Product Change Notification

1. ECN #: 263192

- MODS - SINGLE MODULAR JACKS

- SUB-MODS-F-8P8C-U-TH

The new insulator can be identified through subtle visual differences when viewed from the bottom.

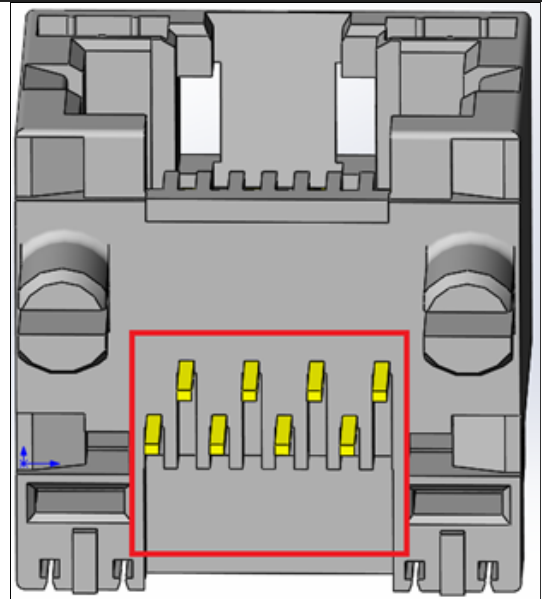
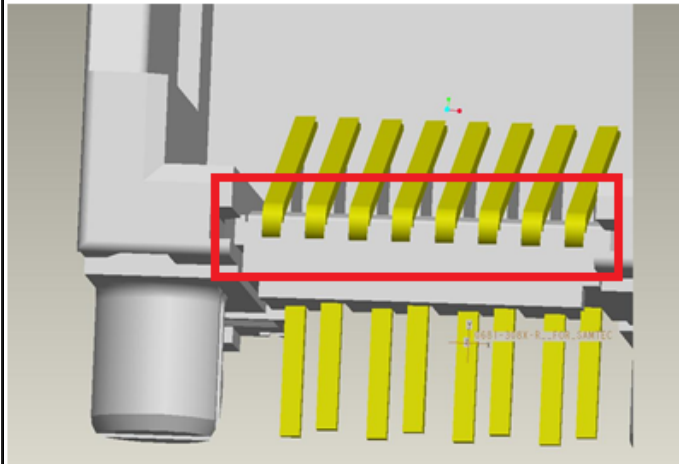
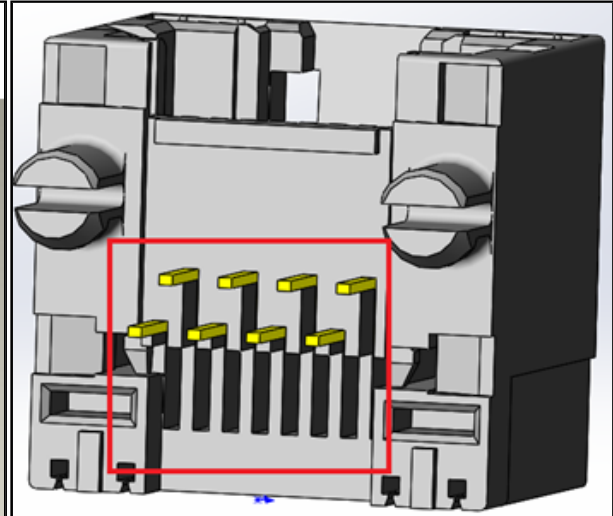
The insulator body will change from a two piece (pin/plastic) to an insert molded type.

The insulator body will change to an insert molded design from a two piece assembled design to eliminate the potential for pin height inconsistencies.

- Form - Visual differences are apparent when viewing the part from the bottom of the connector.
